We are writing this letter on behalf of our client, CB Maddox. Thank you for giving us the opportunity to sit down with you and Kris Klein to discuss the drainage issues relating to the Wedge Meadows Subdivision ("Wedge Meadows") and the construction of Wedge Parkway and Arrowcreek Parkway. Per our April 25th, 2005 meeting I am writing you this letter to clarify what we feel are possible solutions to the drainage issues created by the re-alignment of Wedge Parkway and the placement of related culverts.

To: Kristine Klein, P.E.
From: Mary Horvath, P.E.
CC: Cary Chisum, P.E.; CB Maddox

This memo is essentially the same as the one submitted to Washoe County in July 2004 with minor revisions for increased clarity. It is meant to outline the assessment by Wood Rodgers of the hydraulic conditions of Reach 3 of Whites Creek in the vicinity of the Arrowcreek/Wedge Parkway intersection prior the construction of the roadways. This was done to estimate the quantity of flow that would have reached the Phase VI Wedge Meadows property pre-construction in the statistical 100-year flood event defined as 3000 cfs within Reach 3 of Whites Creek. This memorandum references the figures I provided in

- Figures 1-9: Cross sections of WRC's pre-project HEC-RAS model of Reach 3 of Whites Creek showing the 3000 cfs flow distribution as computed by HEC-RAS (replicated by Wood Rodgers).

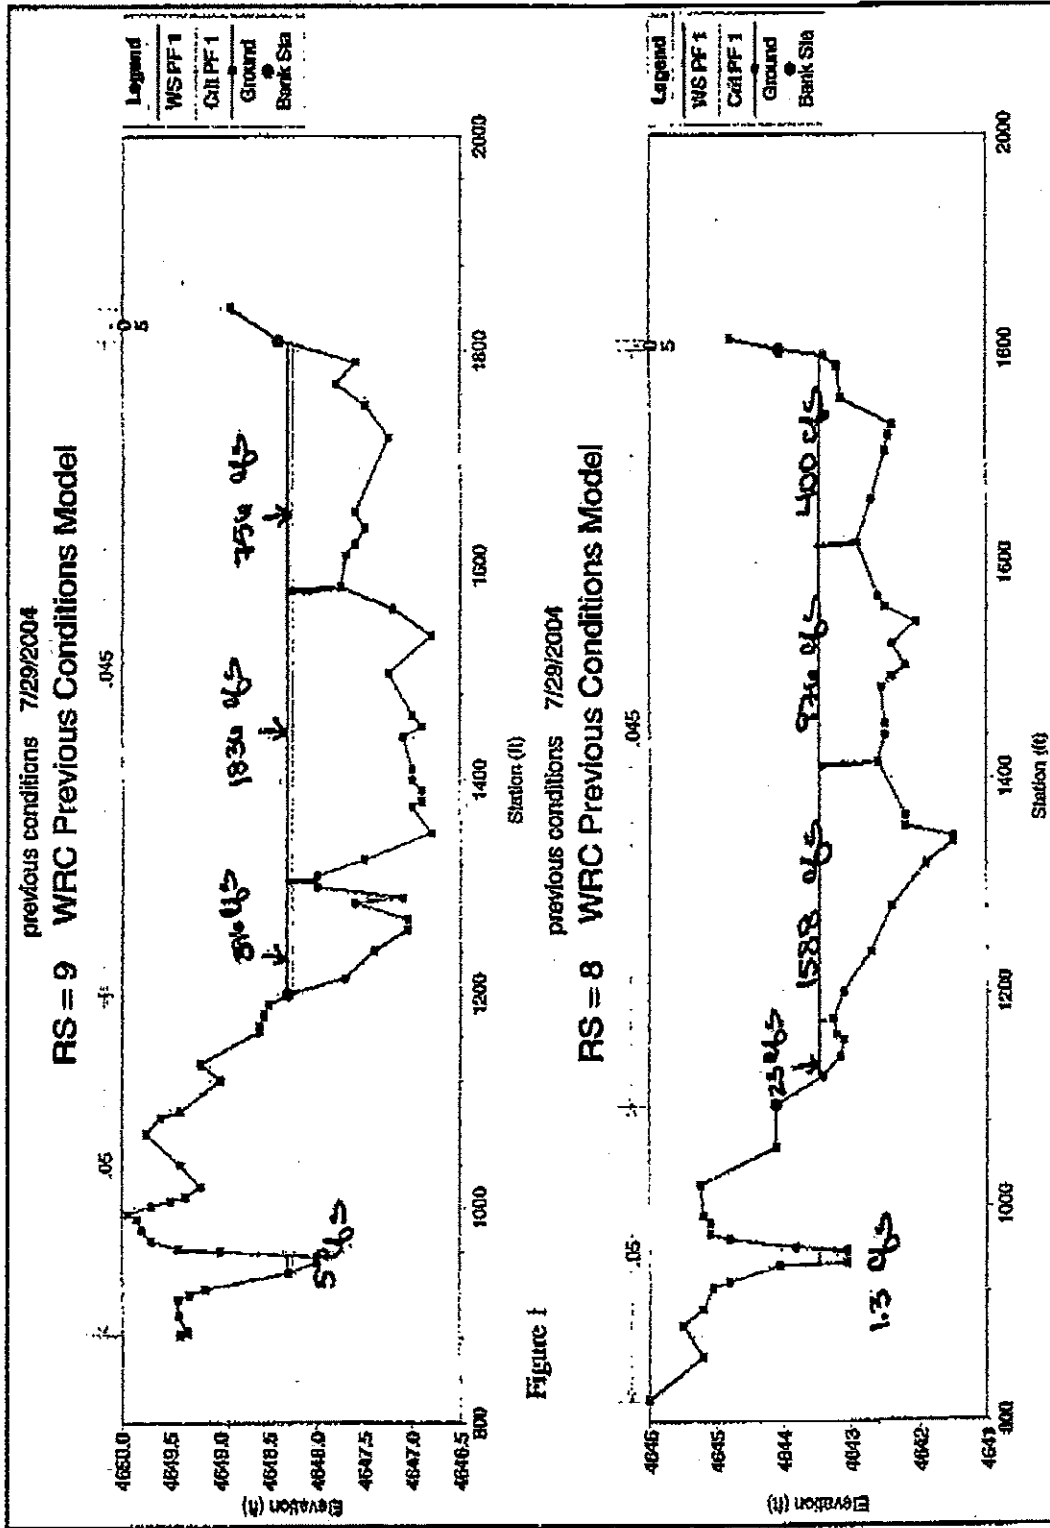
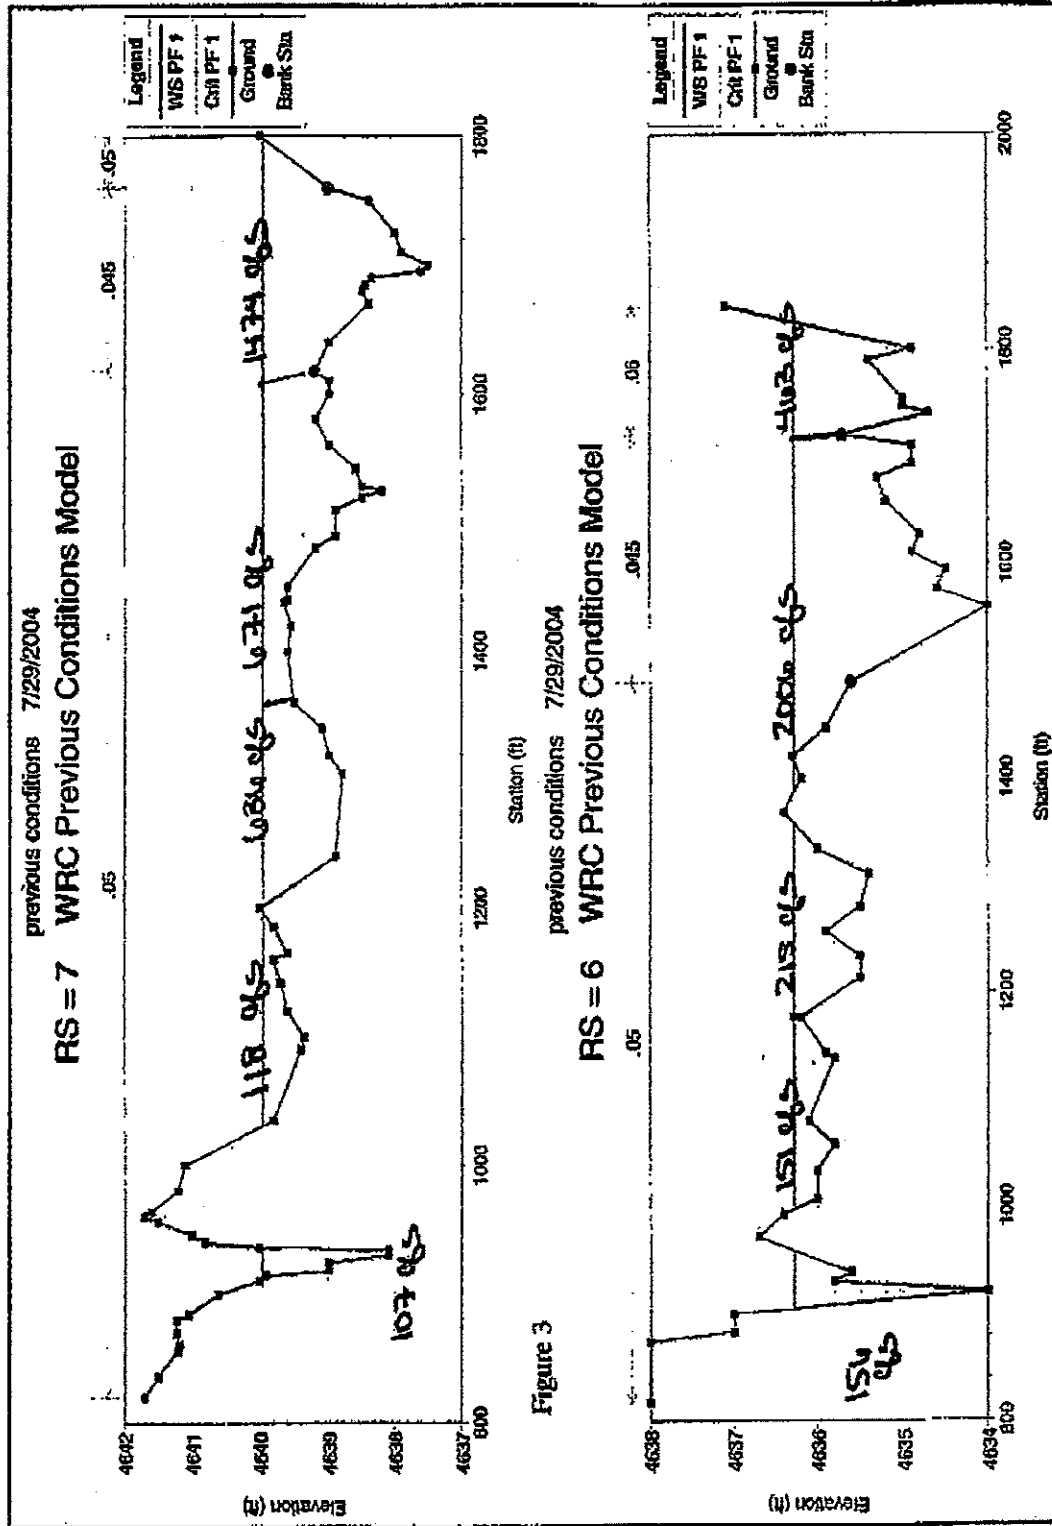
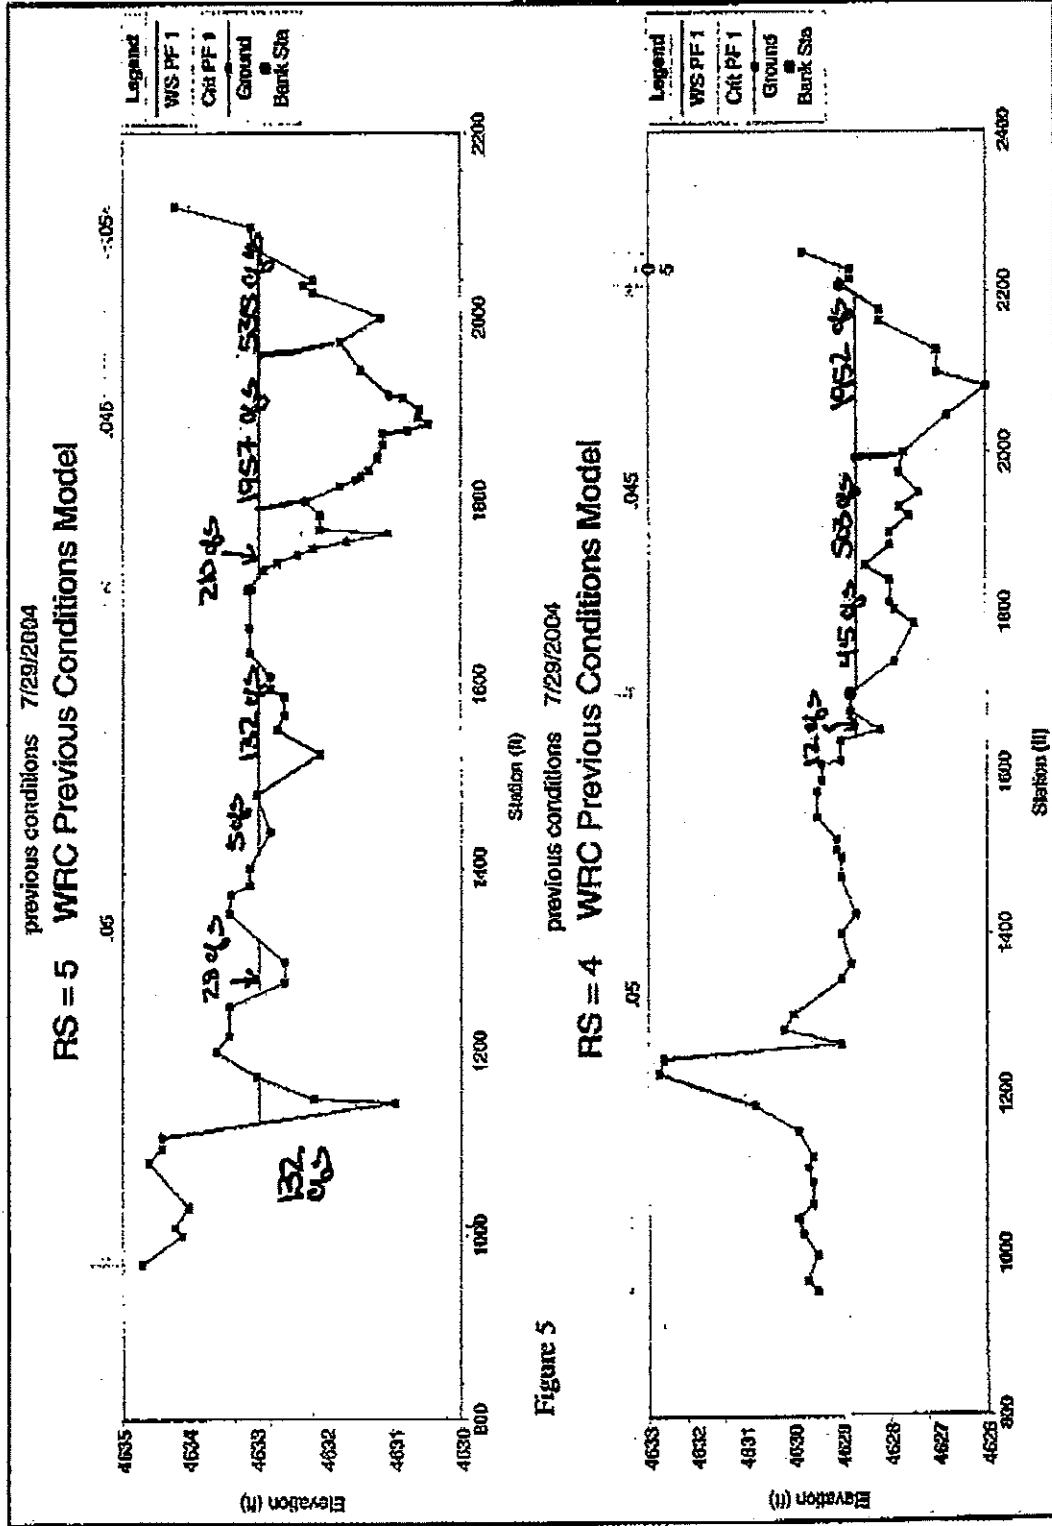
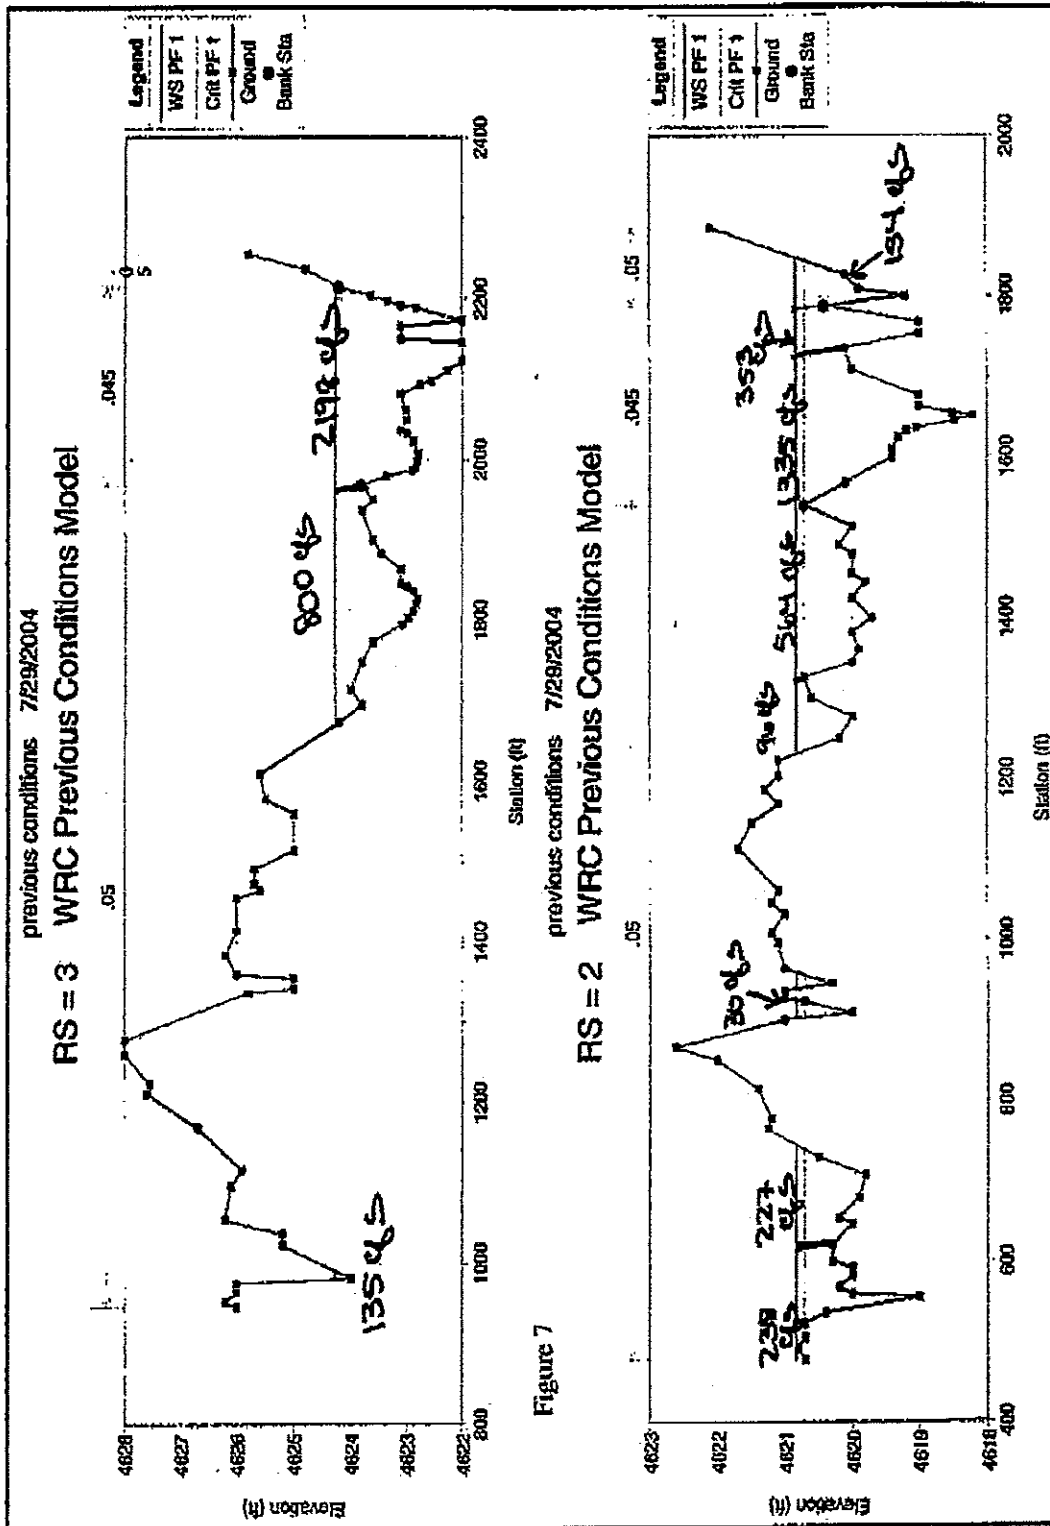
It is our opinion that the cross section placement and orientation in WRC's existing conditions model do not accurately depict flood flow conditions. The cross sections are aligned so that from left to right looking downstream they extend from high to low elevations so that the majority of the flow area is in the right, or southern, portions of the cross sections. As a result of this distortion, the main flow path of Reach 3 along the left side of the floodplain (that was observed flowing during the early summer of 2004) is modeled to be dry or near dry in the 3000 cfs event.

However, since this is what was used for the roadway design, we first used this model for evaluation of Reach 3. Because we could not locate a digital copy of the HEC-RAS model, we replicated the cross sections from the printouts within the WRC report and ran the model with 3000 cfs steady flow. The results matched WRC's results within 0.10 feet for each cross section. We used the flow distribution option within HEC-RAS to compute the quantity of flow within subdivisions of each cross section. The results are presented in Figures 1 through 10. Figures 1 through 9 show the cross sections going from upstream to downstream with the approximate flow distribution (orientation is from left to right looking downstream). Figure 10 shows the plan-view layout of the pre-project WRC model with the numerical flow distribution shown in red for each cross section. The majority of the 3000 cfs is distributed within the right or southern portions of the cross sections in cross sections 9 through 2. Cross section 1 is shorter than 2 through 9 so that it cuts off the flow paths within the southern portions of floodplain, forcing the majority of the flow to be within the center of the cross section and putting more water in the left side and forcing the floodplain to extend to the north.
